<b>Docket Number:</b>	17-BSTD-02
<b>Project Title:</b>	2019 Title 24, Part 6, Building Energy Efficiency Standards Rulemaking
<b>TN #:</b>	222905
<b>Document Title:</b>	McHugh Energy Consultants Comments Flicker Reporting in Reference Appendix JA8
<b>Description:</b>	N/A
<b>Filer:</b>	System
<b>Organization:</b>	McHugh Energy Consultants
<b>Submitter Role:</b>	Public
<b>Submission Date:</b>	3/6/2018 1:26:18 PM
<b>Docketed Date:</b>	3/6/2018

**Flicker Reporting in Reference Appendix JA8**

**Re: Docket No. 17-BSTD-02 – Flicker Reporting in Reference Appendix JA8**

**Figure 1: IEEE PAR 1789-2015 Low Risk and No Risk Regions**

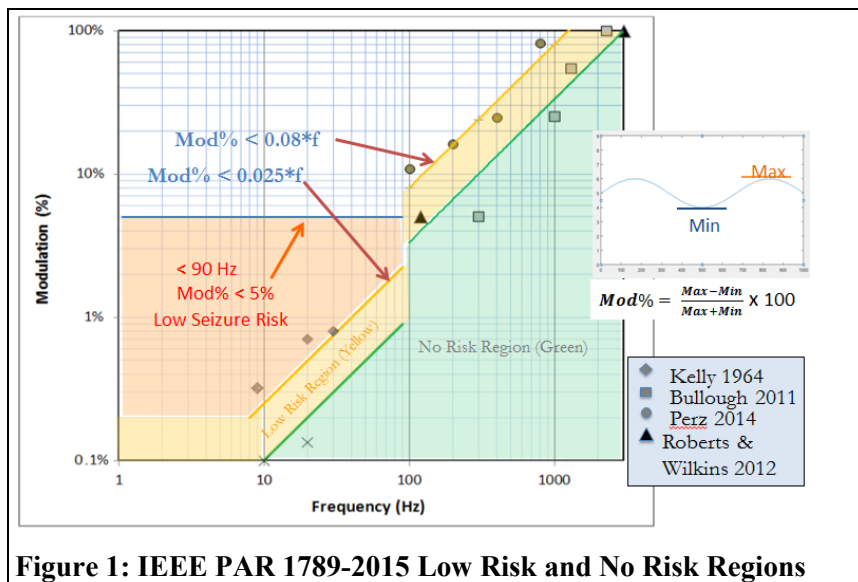
A key outcome of this synthesis of the research to date was a recommendation document that included a two dimensional risk map of frequencies and modulation (%) as shown **Figure 1**, with three primary regions: 1) No Risk Region (Green) where there is little expectation of any physiological effect, also known as the “No Observable Effect Level” (NOEL). This is where physiological response so far is not measurable. 2) Low Risk Region (Yellow) where a physiological response is detected but the response is

small and deemed to be unlikely to be damaging and 3) Not Low Risk Region (White) where there may be a range of risk from not much risk to the severe risk associated with triggering epileptic seizures or vertigo with relatively modest amplitude modulation at low frequencies. If it turns out that designing LED drivers to meet the IEEE standard is relatively inexpensive and does not have other deleterious effects on performance, this would seem to be the prudent thing to do.

**Figure 2: JA10 broadband modulation data for showing compliance with IEEE PAR 1789 guidelines for low risk**

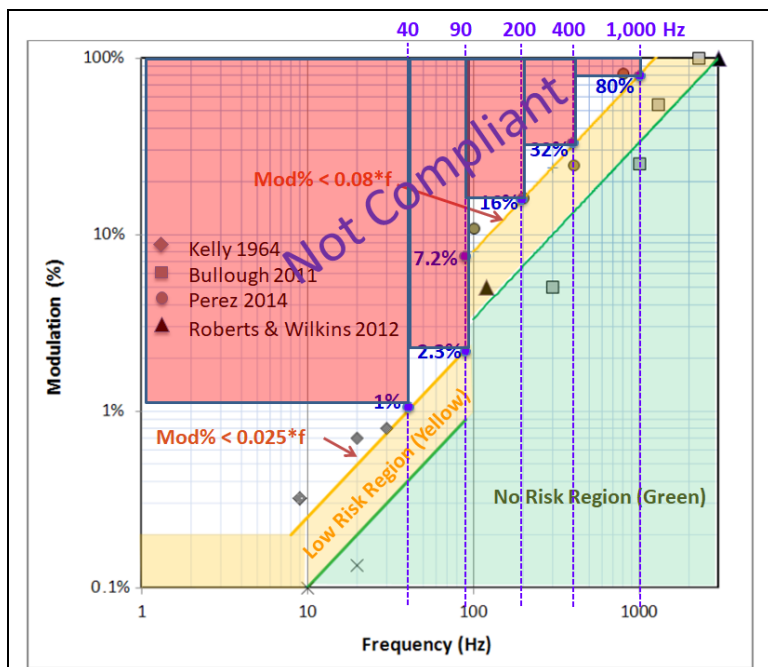
Products that comply with the maximum percent amplitude modulation in **Table 1** would reflect equipment performance below the red boxes shown in **Figure 2**. In other words products with amplitude modulation above the limits listed when plotted would be in one of the red boxes in the upper left-hand corner of Figure 2 that are labelled “Not Compliant.”

The 16% modulation limit for the low-pass filtered results with 200 Hz cut-off frequency is around 0.58 SVM for a 120 Hz sinusoidal waveform. This is significantly less than the 1.6 SVM proposed criteria in NEMA 77. The JA10 metric evaluates percent modulation of the waveform of the light output with all the frequency components above the cut-off frequency removed.

The first two columns of this table would reflect equipment performance below the red boxes shown in Figure 2. As discussed above, the third column represents some relief when dimmed to 20% by requiring the IEEE standard for most of the frequencies, but for the data where the virtual low pass filter has a 90 and 200 Hz cut-off frequency, the maximum amplitude values are equivalent to 1.4 times the IEEE PAR 1789 recommended values. These increased values are in the shaded cells in the third column. Note when dimmed to 20%, the 22% maximum amplitude modulation value for the 200 Hz cut-off frequency is comparable to a SVM = 0.78 for a 120 Hz sinusoidal waveform. This would address all the light sources except directional lamps. A similar approach could be used to evaluate what are
